\* NP100 upgrade FOR SA.12 OR SA.100

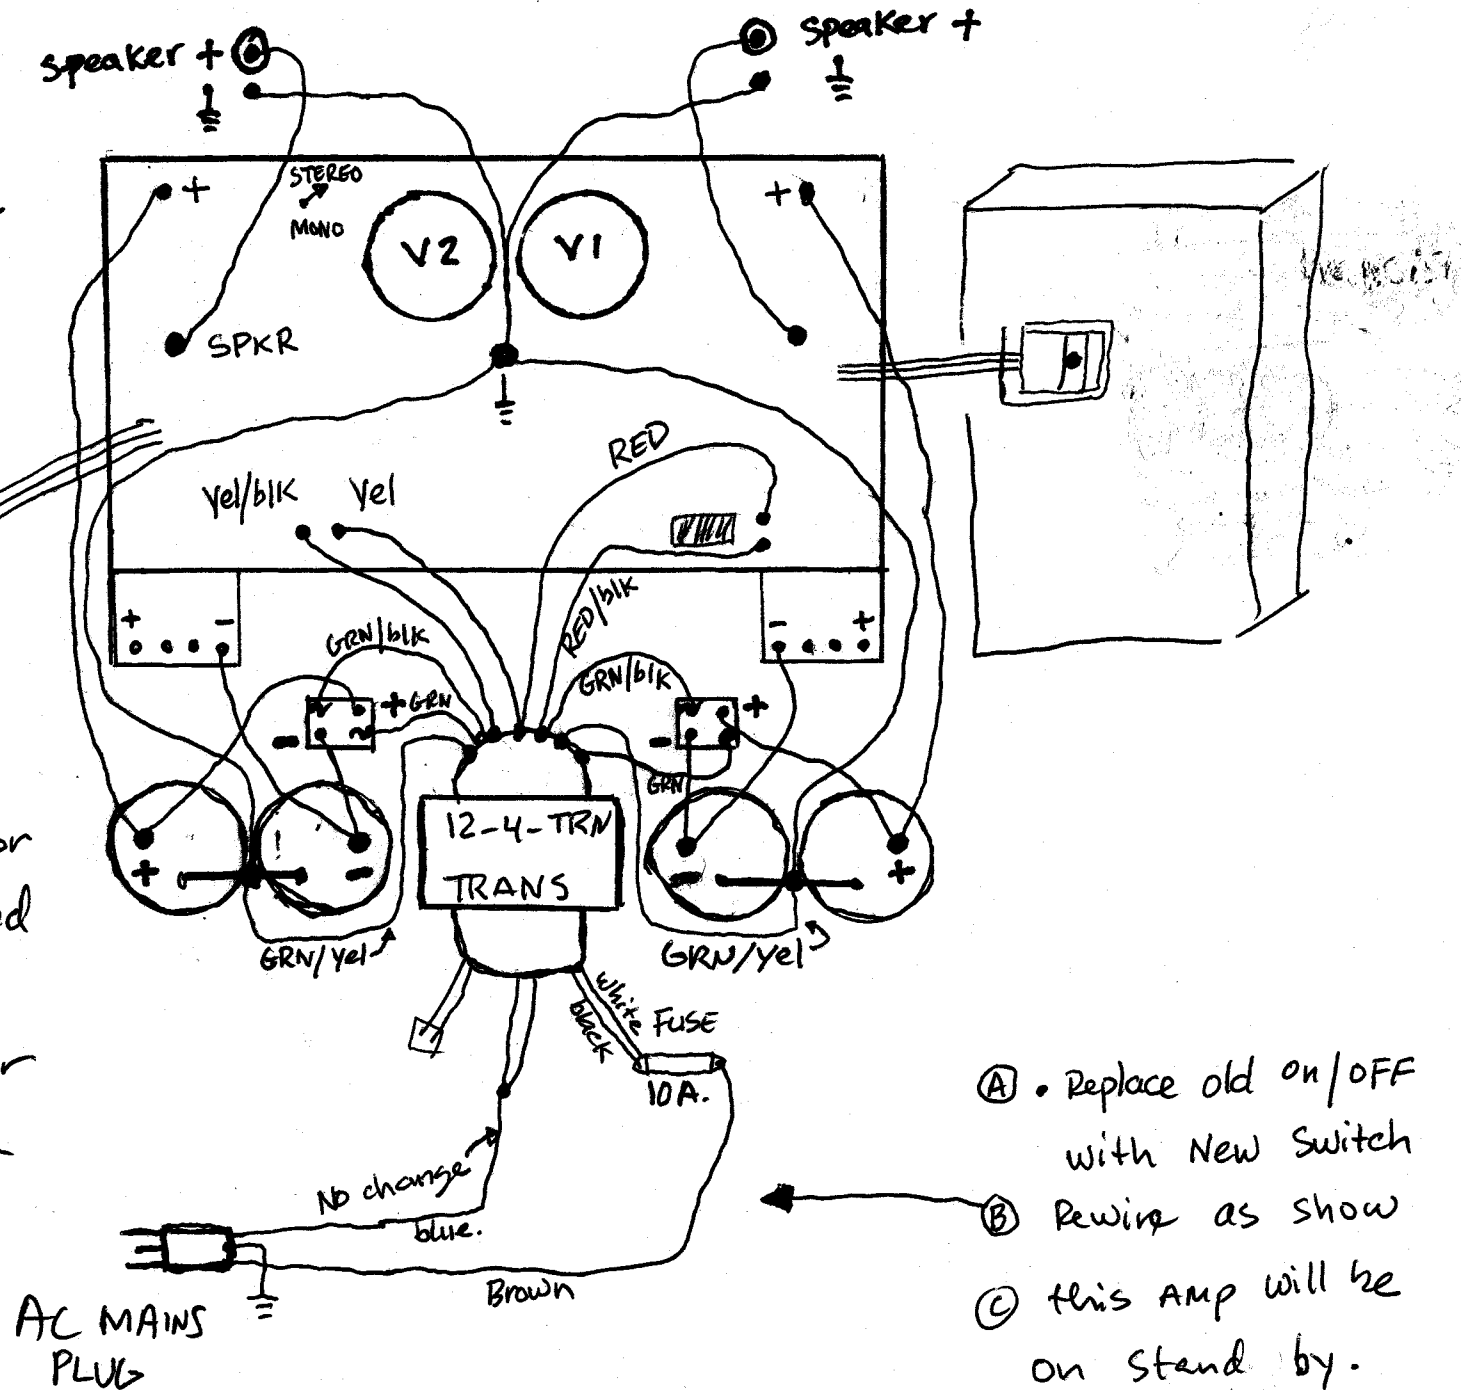
(A) Low Gain Version use  
6SN7 x 2

(B) High gain Version use  
6SL7 x 2

① enlarge old heat sensor transistor hole to 1/8" and deburr.

② Mount New heat sensor transistor on heat sink where the old one was.

- (A) • Replace old on/off with New Switch
- (B) Rewire as show
- (C) this Amp will be on Stand by.
